EOG Resources requests an amendment to our approved APD for this well to reflect a change in surface hole location, TVD target, casing, and well name/number.

Condor 32 State #310H  
Lea County, New Mexico

Proposed Wellbore  
Revised 5/14/18  
API: 30-025-44675

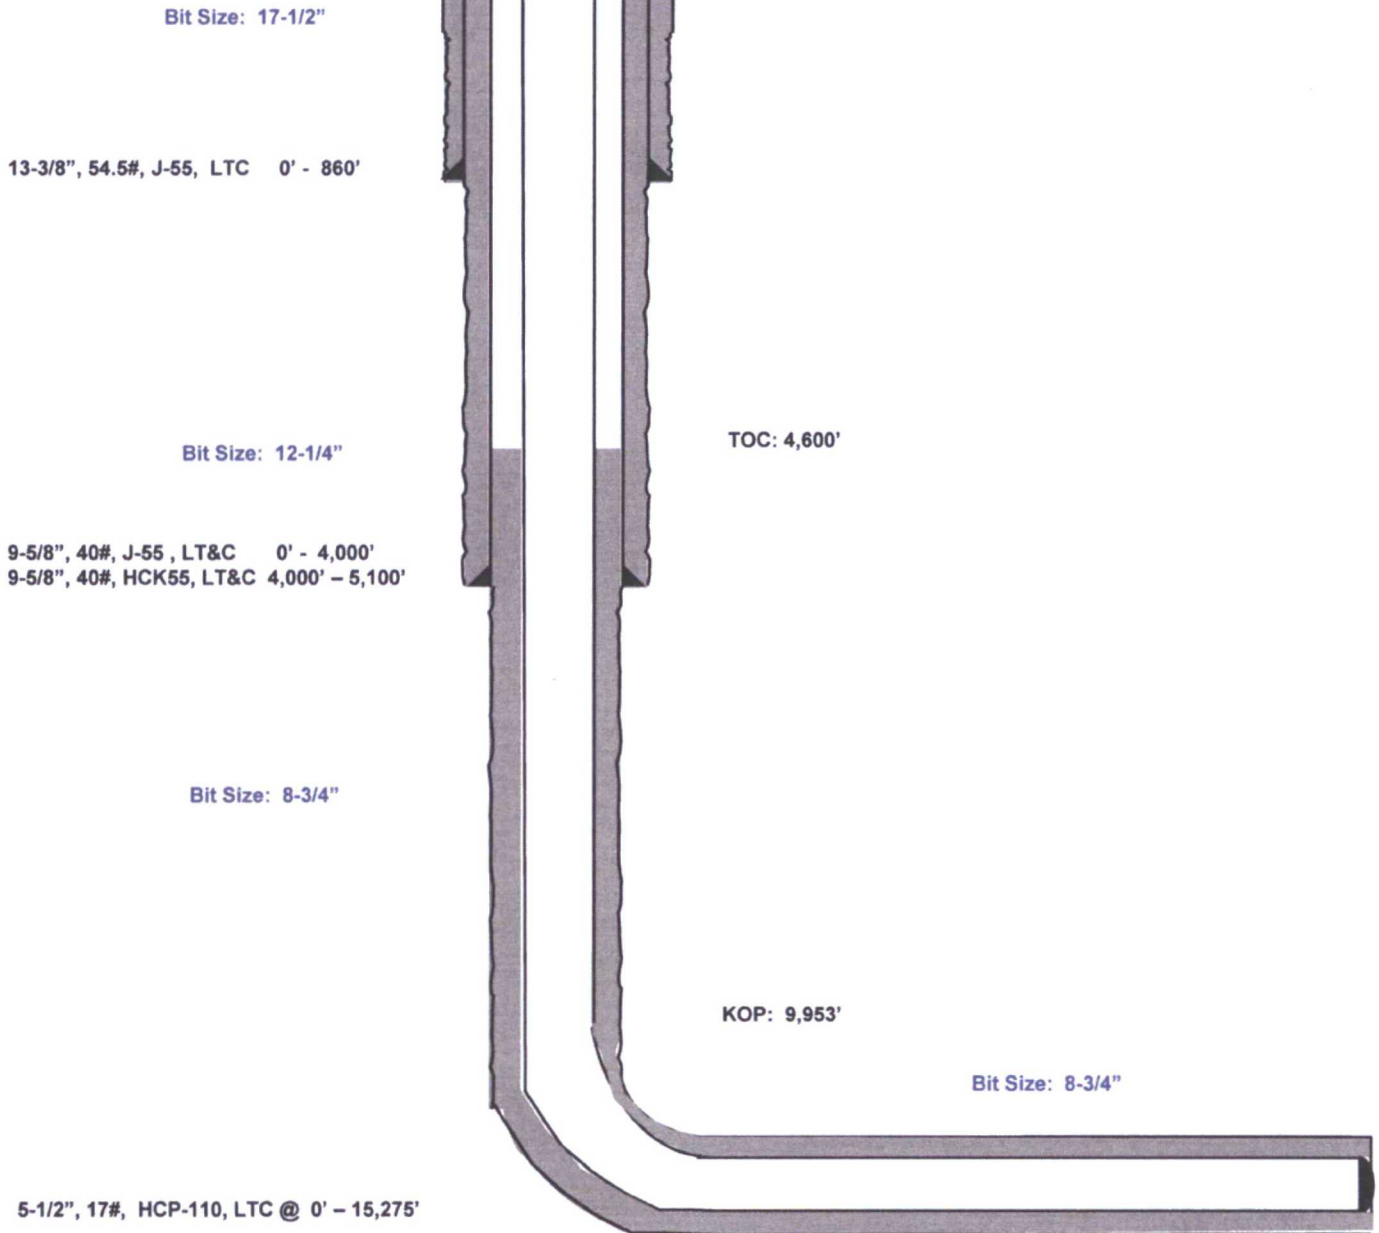
Change SHL to: 843' FNL & 2490' FWL C-32-25S-34E  
Change TVD to: 10425' 1st Bone Spring Sand  
Change casing as attached.  
Change well name/number to: Condor 21 State 310H

KB: 3,345'  
GL: 3,320'

Lateral: 15,275' MD, 10,425' TVD

BH Location: 230' FSL & 2313' FEL  
Section 32  
T-25-S, R-34-E
